**Comments on Draft 2021 Integrated Energy Policy Report, Vol III
Decarbonizing the State's Gas System**

Re: Docket No. 21-IEPR-01
Draft 2021 Integrated Energy Policy Report, Vol. III: Decarbonizing the State’s Gas System

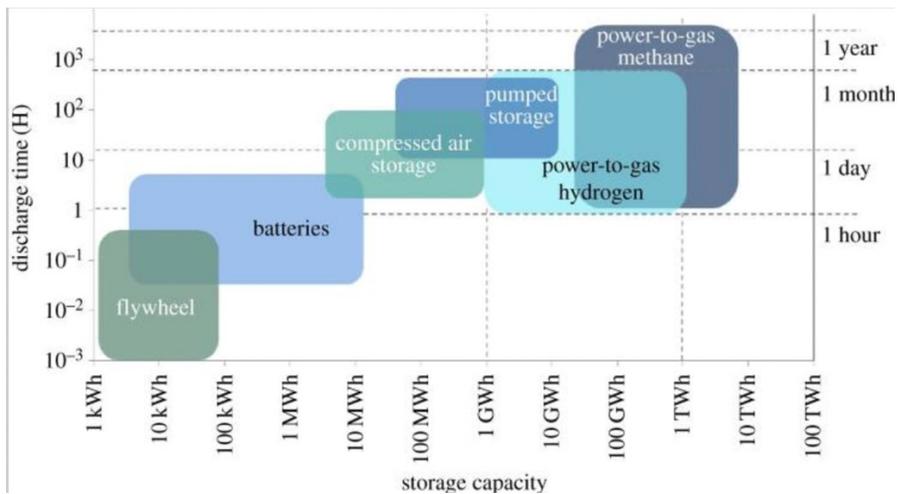
- a. *An addition is requested on page 59 regarding methanation as relevant to renewable gas generation*

The section entitled Converting Biogas to Renewable Gas beginning on page 59, describes the process in which the methane is separated from the other components of biogas; biogas is typically 60% methane and 40% CO₂. Methods that are currently used in the field result in the release of the CO₂ present in the biogas. In this section of the IERP, it should be mentioned that there is an industrial scale process that can be used to convert the CO₂ into renewable methane using a methanogenic microorganism and green hydrogen. This method can increase the production of renewable gas by 70-100%, while eliminating the release of climate-damaging CO₂, and instead recycling the carbon into a low-carbon intensity fuel. Methanation can be completed by a chemical catalyst in the Sabatier process³ or by a biological catalyst in the biomethanation process⁴. Both of these processes use the CO₂ in the production of methane instead of releasing it into the environment. When renewable electricity is used in the process, the resulting product is a renewable gas.
